February 27, 2014
RC-14-0030

Subject: VIRGIL C. SUMMER NUCLEAR STATION (VCSNS) UNIT 1
DOCKET NO. 50-395
OPERATING LICENSE NO. NPF-12
SOUTH CAROLINA ELECTRIC & GAS COMPANY'S SECOND SIX-MONTH
STATUS REPORT IN RESPONSE TO MARCH 12, 2012 COMMISSION ORDER
MODIFYING LICENSES WITH REGARD TO REQUIREMENTS FOR
MITIGATION STRATEGIES FOR BEYOND-DESIGN-BASIS EXTERNAL
EVENTS (ORDER NUMBER EA-12-049) (TAC NO. MF2338)

Attachment I SCE&G's Second Six Month Status Report for the Implementation of Order EA-12-049, Order Modifying Licenses with Regard to Requirements for Mitigation Strategies for Beyond-Design-Basis External Events

Attachment II Conceptual Sketches of Strategies

Figure 6 – Conceptual FLEX UHS Water Supply Routing to Containment Cooling

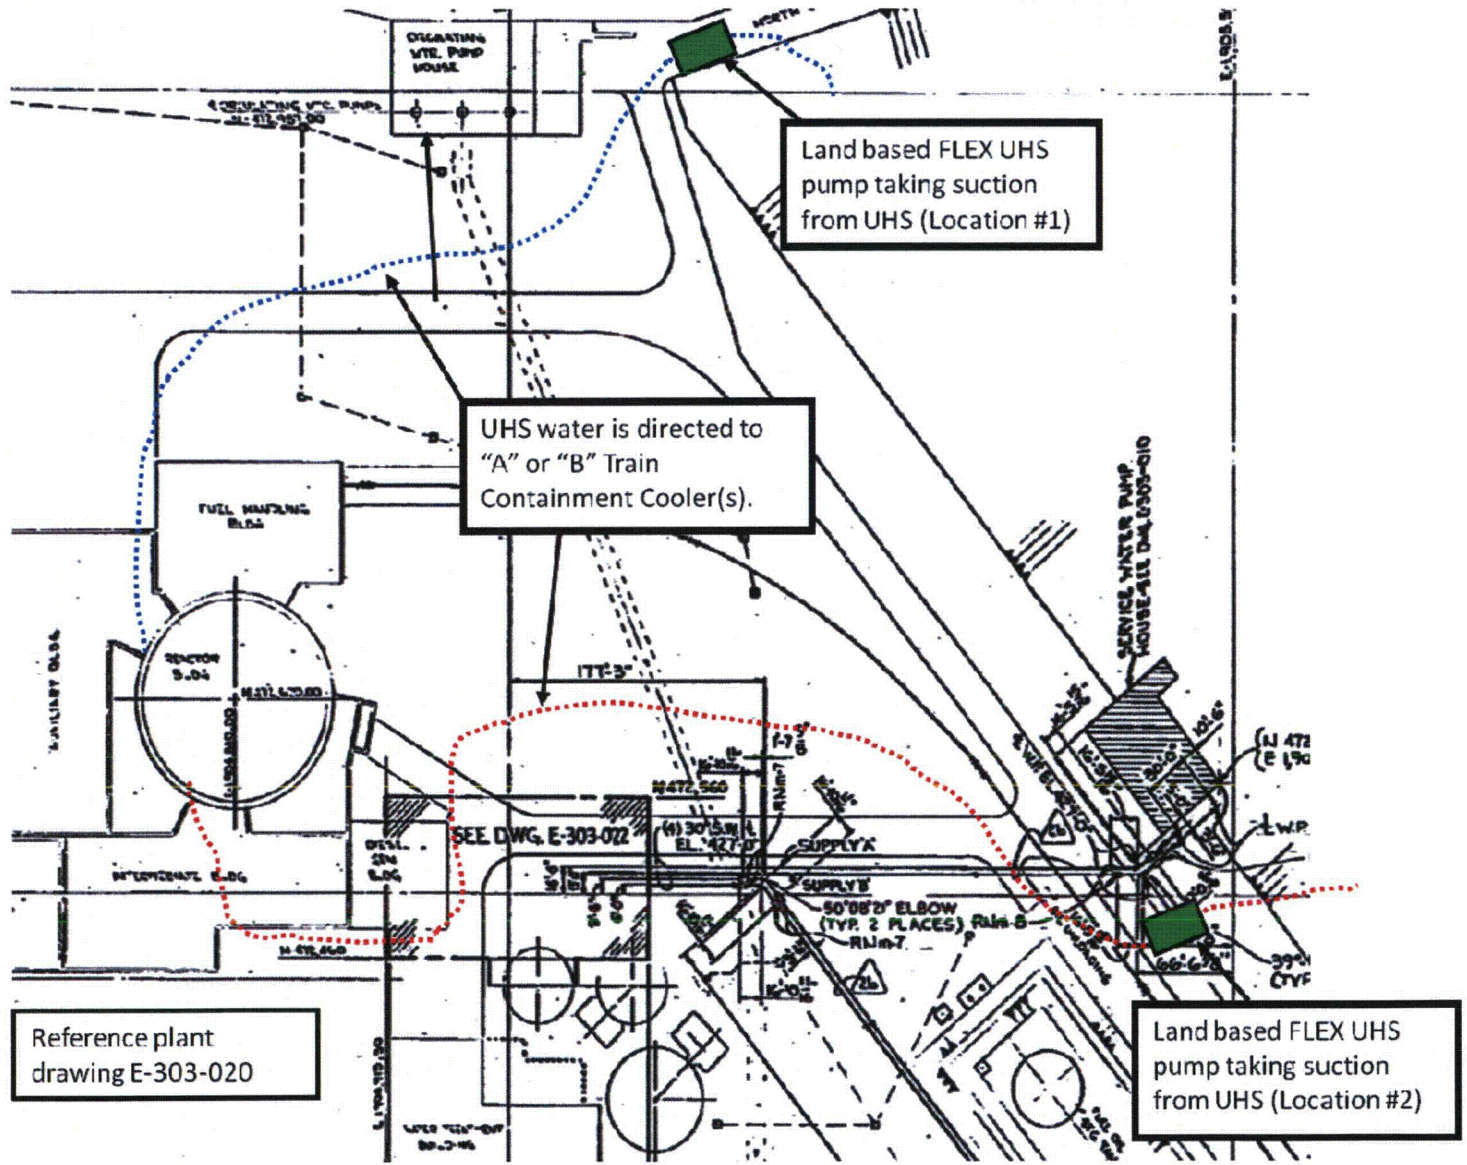
Figure 6 – Conceptual FLEX UHS Water Supply Routing to Containment Cooling was revised, renamed, and reissued in Attachment II of the first six-month status report. The figure was renamed to remove reference to Spent Fuel Pool cooling in the title.

Figure 8 – Conceptual FLEX Feed Header Layout

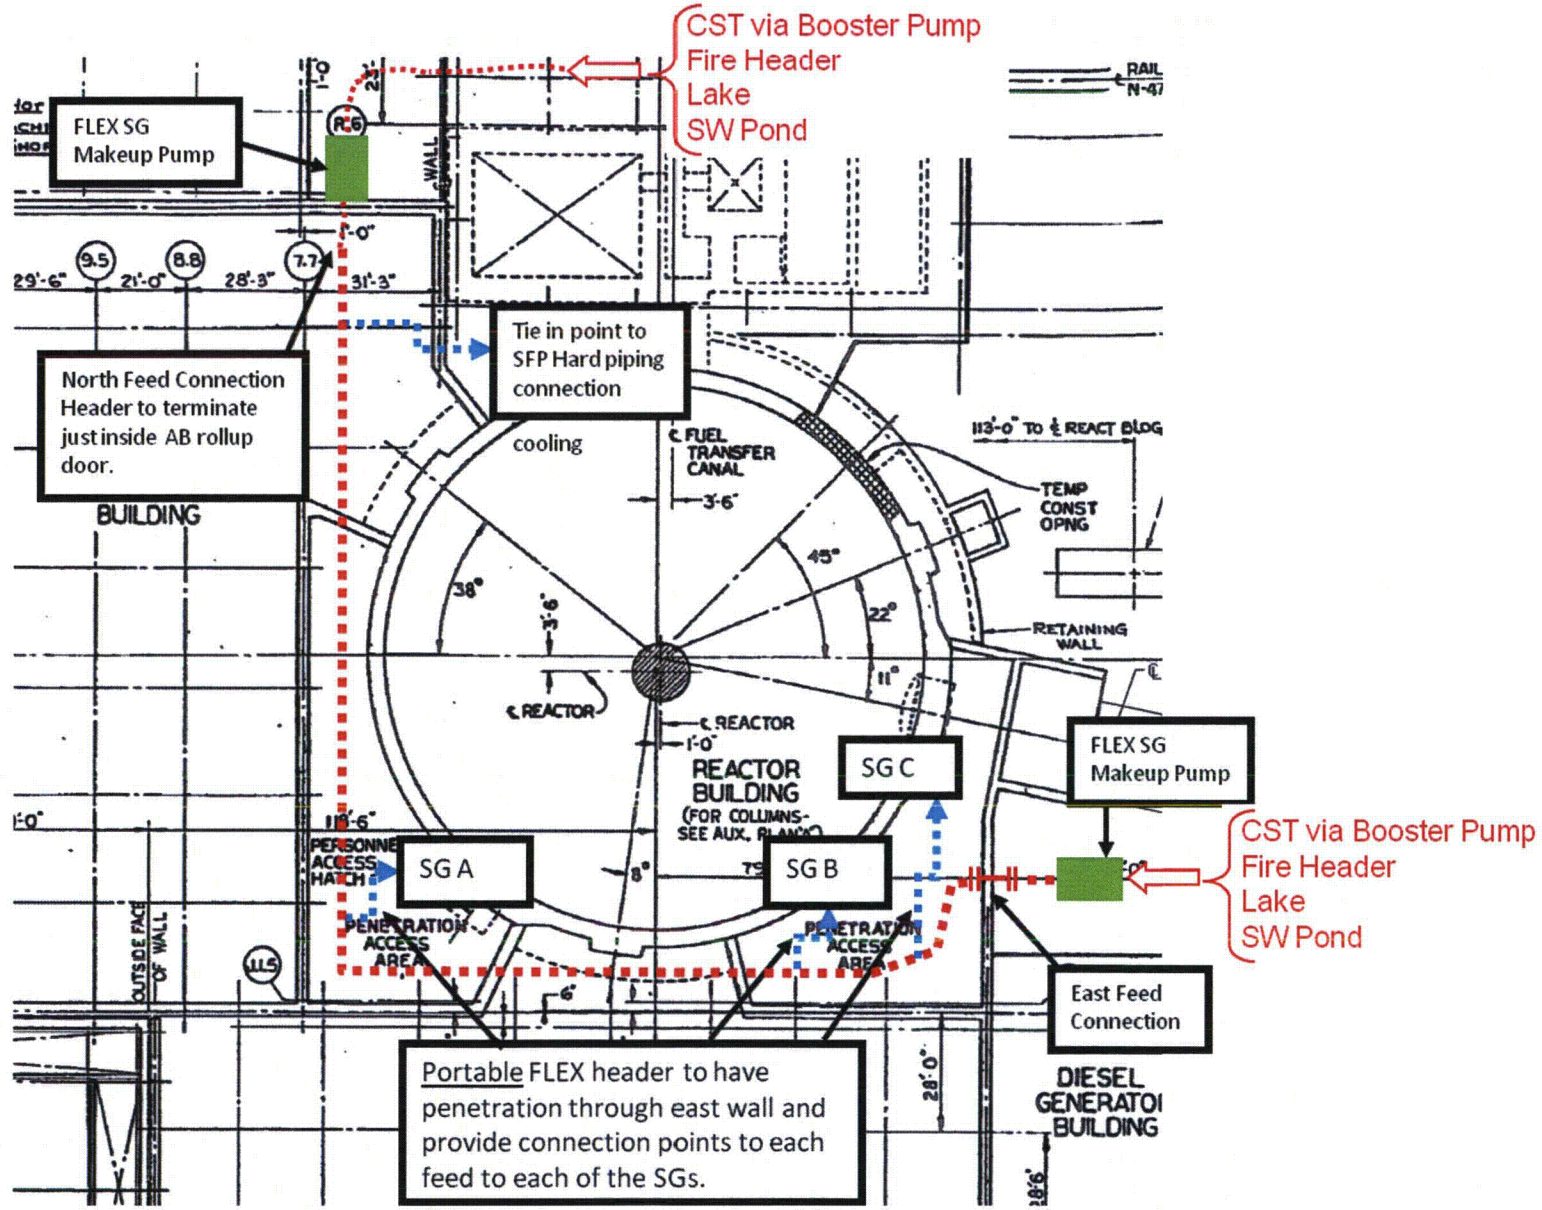
Figure 8 – Conceptual FLEX Feed Header Layout was revised and reissued in Attachment II of this submittal. The significant changes to the figure are as follows: (1) eliminated FLEX SG Makeup Pump from CAR and placed near east feed connection, (2) revised FLEX header to indicate it is portable, and (3) identified possible water sources for SG makeup.

Figure 9 – Conceptual Coping Strategy to Repower 7.2kV bus

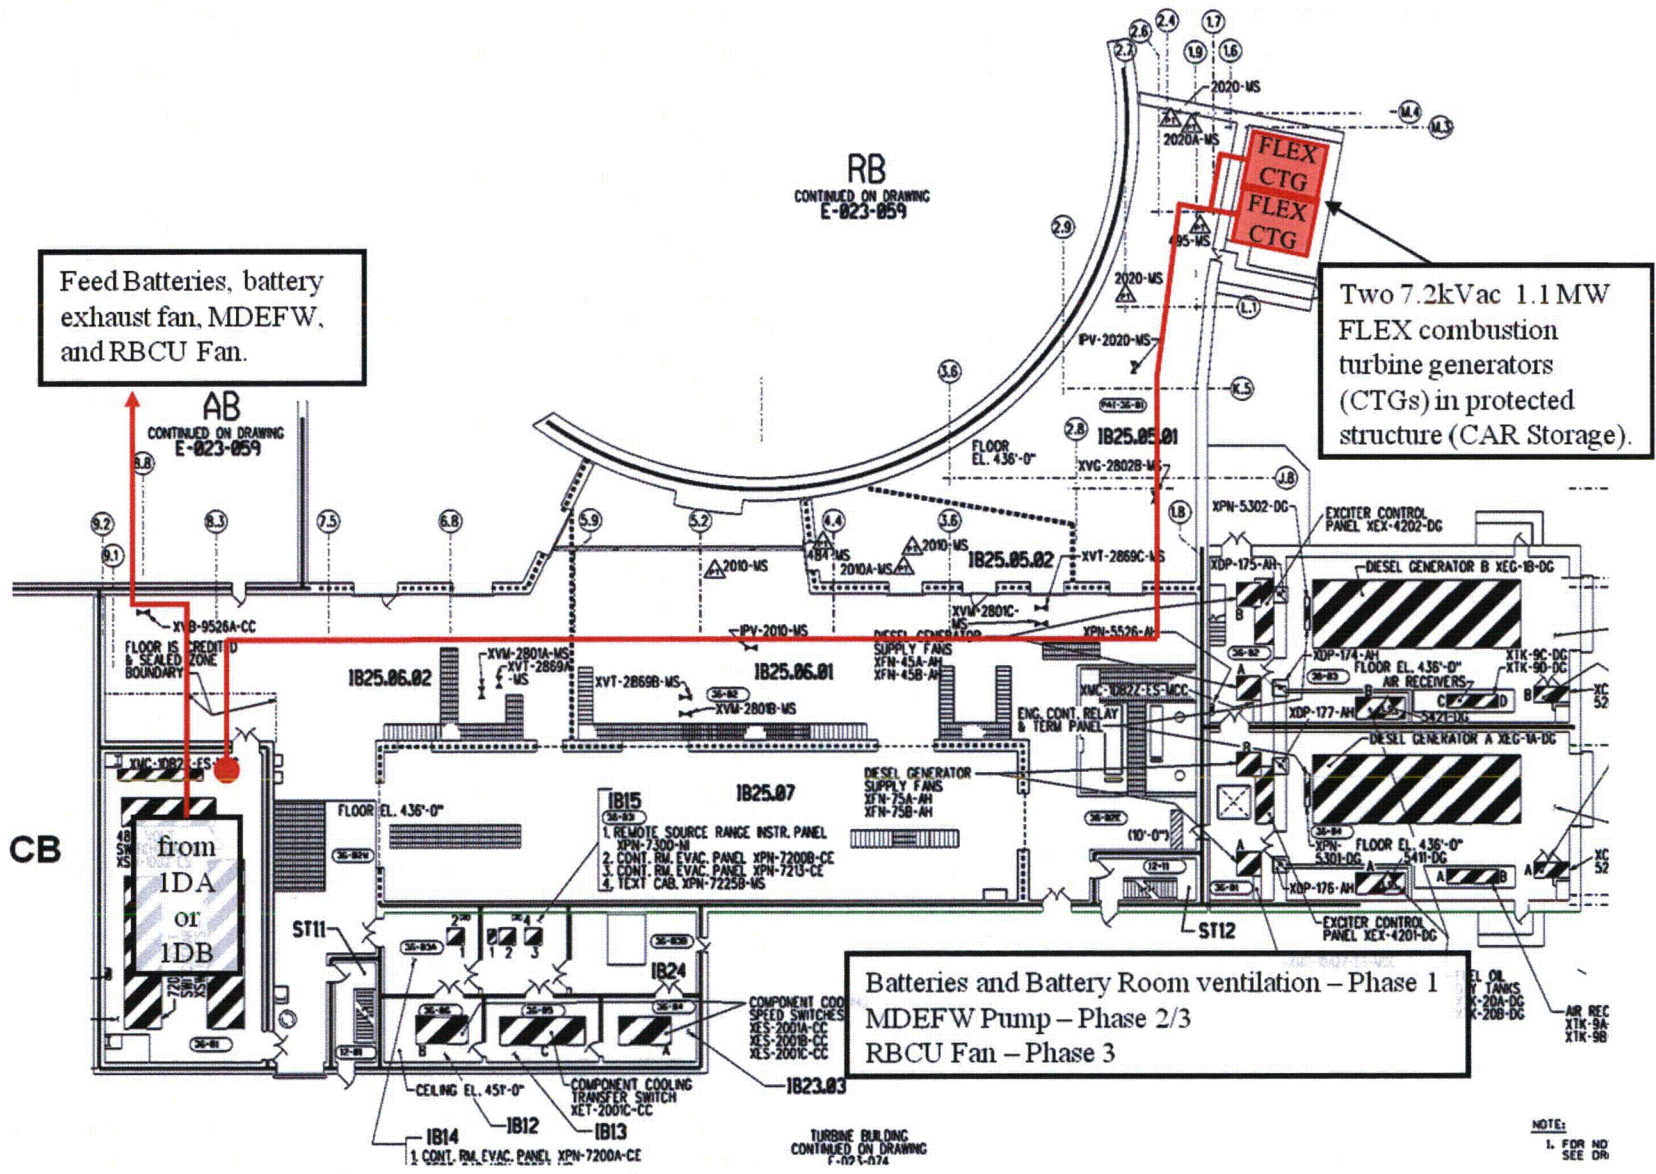
Figure 9 – Conceptual Coping Strategy to Repower 7.2kV bus was revised, renamed, and reissued in Attachment II of this submittal. The significant changes to the figure are as follows: (1) renamed figure to reflect repowering 7.2 kilovolt bus, (2) revised size, type, and number of generators in the CAR storage, and (3) eliminated repowering ASI Pump and Reactor Makeup (RXMU) FLEX Pump.

Figure 11 – FLEX Strategy Conceptual Mechanical Diagram

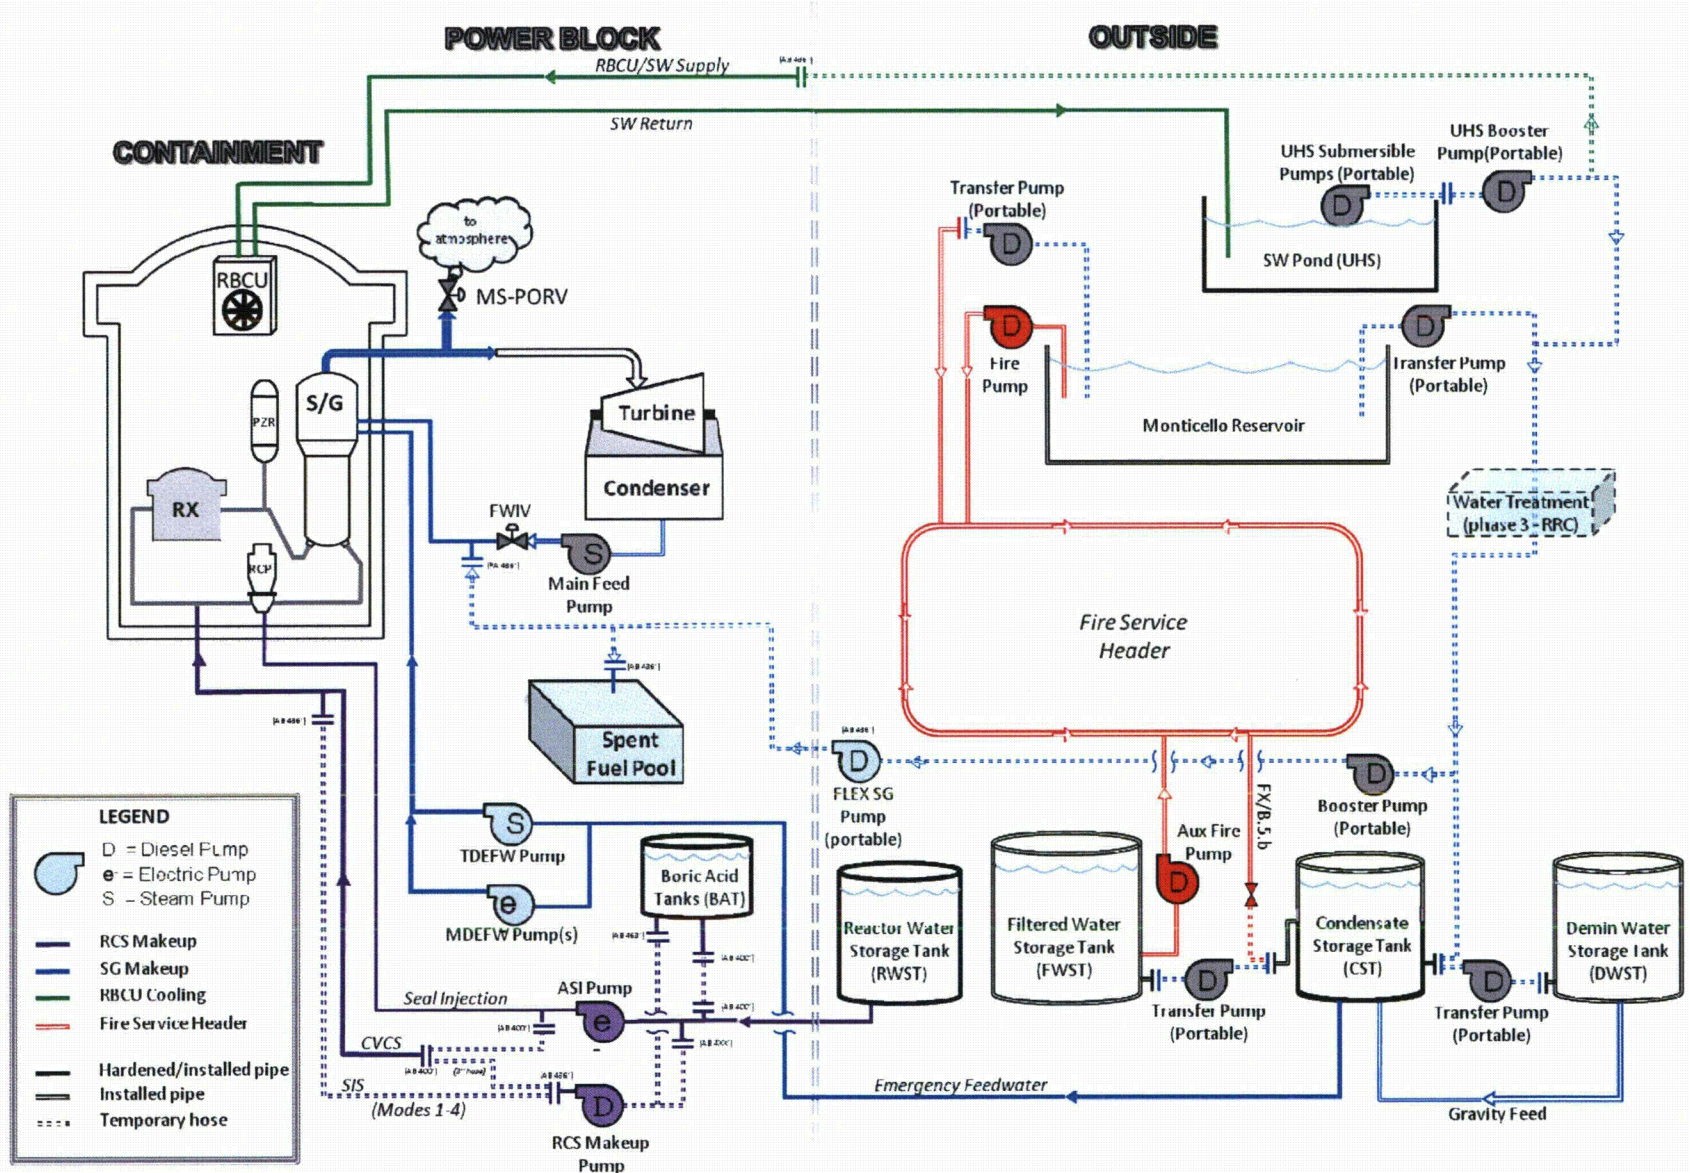
Figure 11 – FLEX Strategy Conceptual Mechanical Diagram was added in Attachment II of this submittal to provide a conceptual diagram of the interactions between strategies, water sources, and equipment.

Figure 12 – FLEX Strategy Conceptual Electrical Diagram

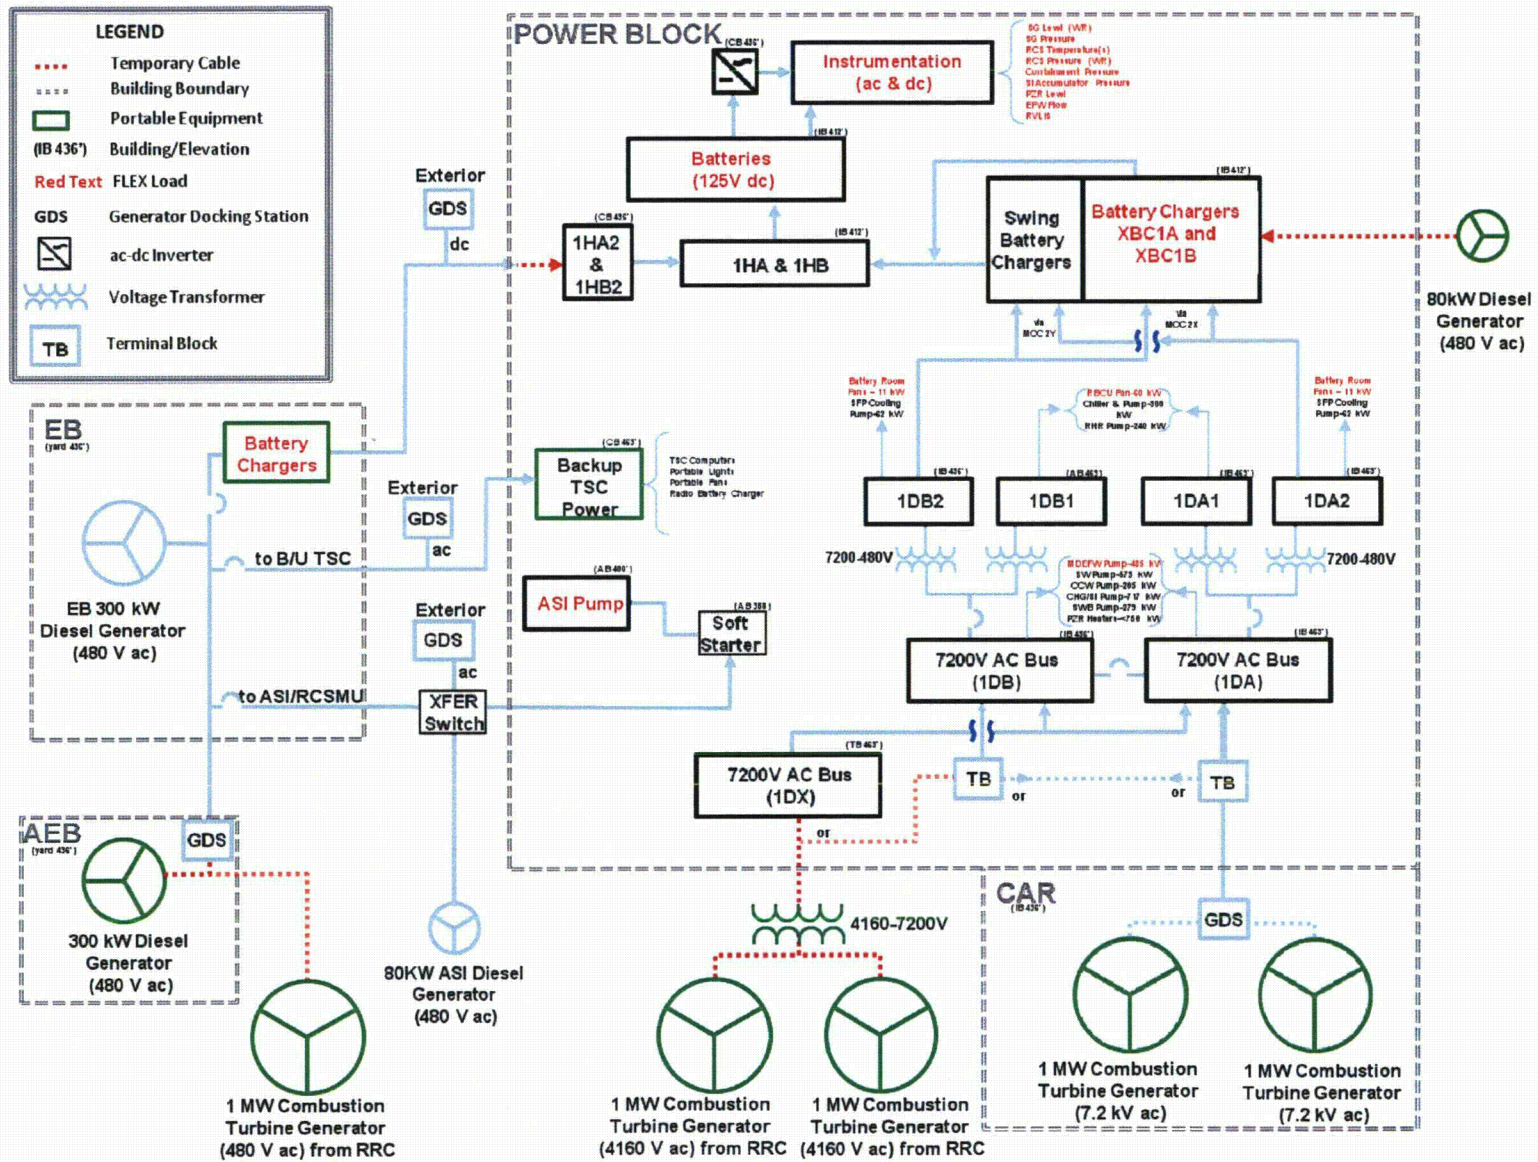
Figure 12 – FLEX Strategy Conceptual Electrical Diagram was added in Attachment II of this submittal to provide a conceptual diagram of the interactions between strategies, generators, and equipment.
